UNITED STATES
DEPARTMENT OF THE INTERIOR
BUREAU OF LAND MANAGEMENT

SUNDRY NOTICES AND REPORTS ON WELLS
Do not use this form for proposals to drill or to re-enter an abandoned well. Use form 3160-3 (APD) for such proposals.

8. Well Name and No.
NFE FEDERAL (308724) 016

Apache would like to recomplete in the Glorieta-Yeso per the attached procedure and commingle all zones.

Apache Corp.
Current Wellbore

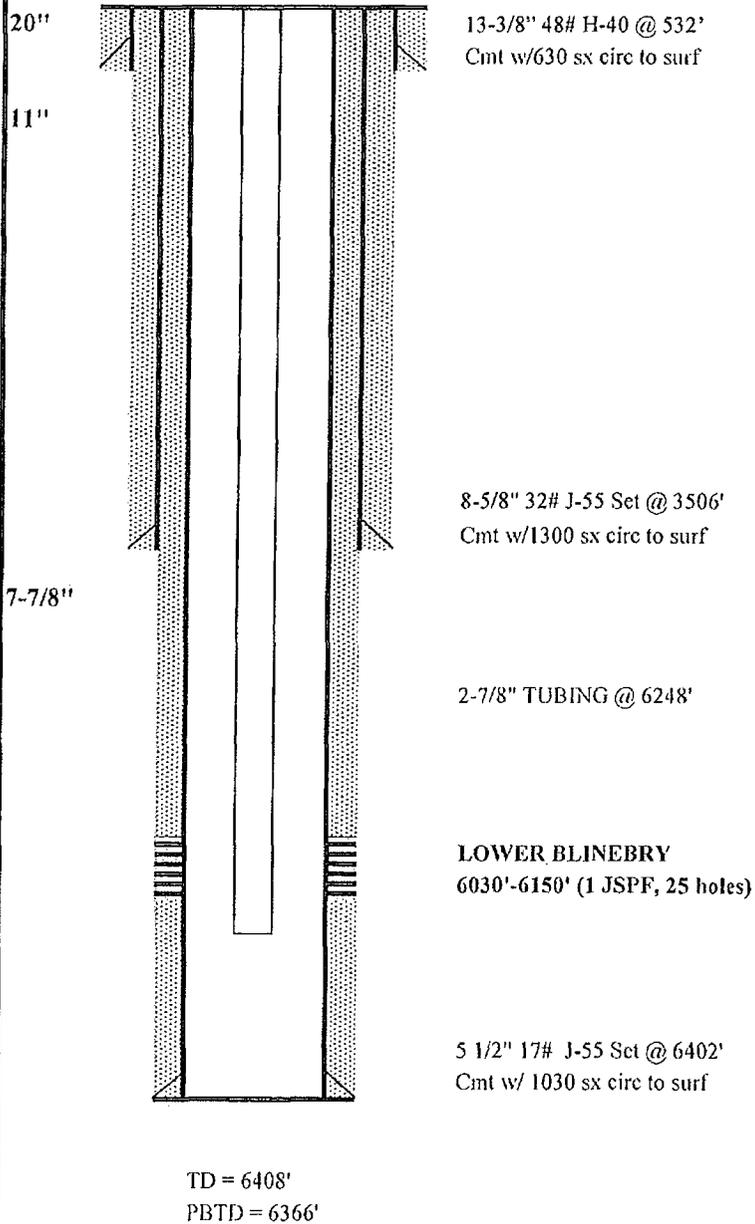
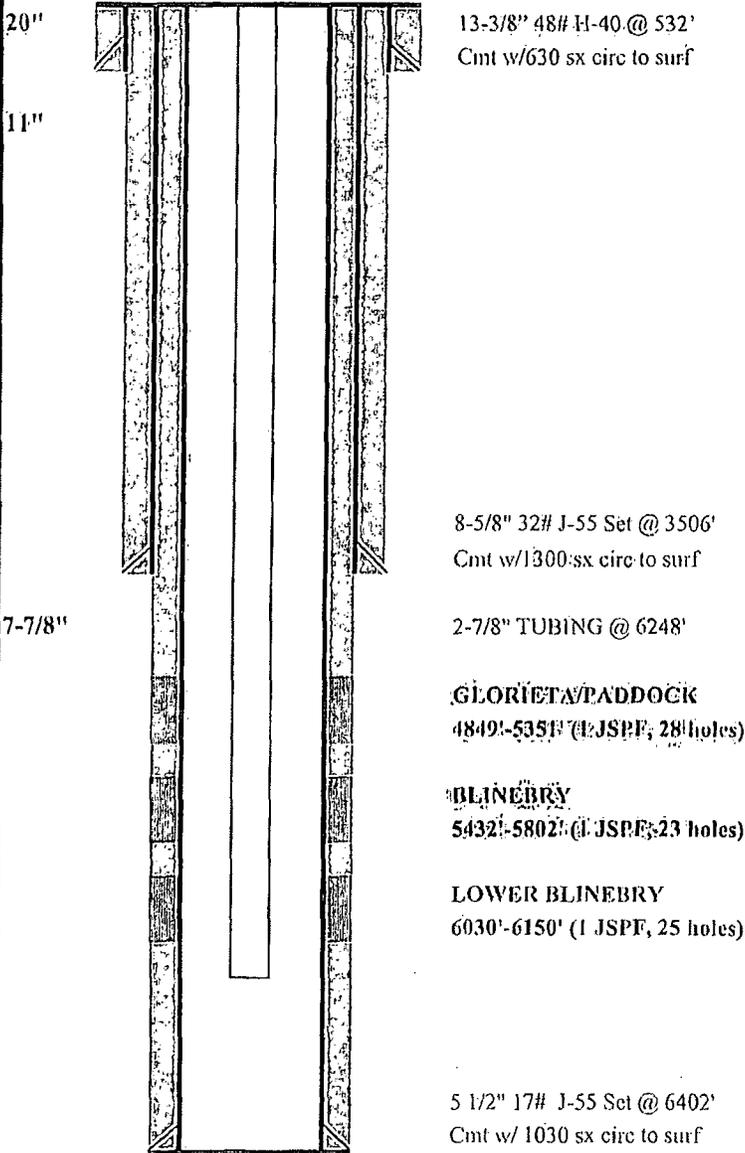
- 1. Must conduct a casing integrity test to maximum treating pressure before any work can be done. Submit results to BLM. The CIT is to be performed on the production casing per Onshore Oil and Gas Order 2.III.B.1.h. Submit results to the BLM.**

- 2. Recompletion procedure approved as written.**
- 3. Operator has been approved for this zone, Cedar Lake; Gloreita-Yeso (pool code 96831) which includes the Paddock and the Blinebry, so no NOI is necessary only a subsequent report is needed after pay has been added.**

10. Subsequent sundry required detailing work done and completion report with both formations. Operator to include well bore schematic of current well condition when work is complete.
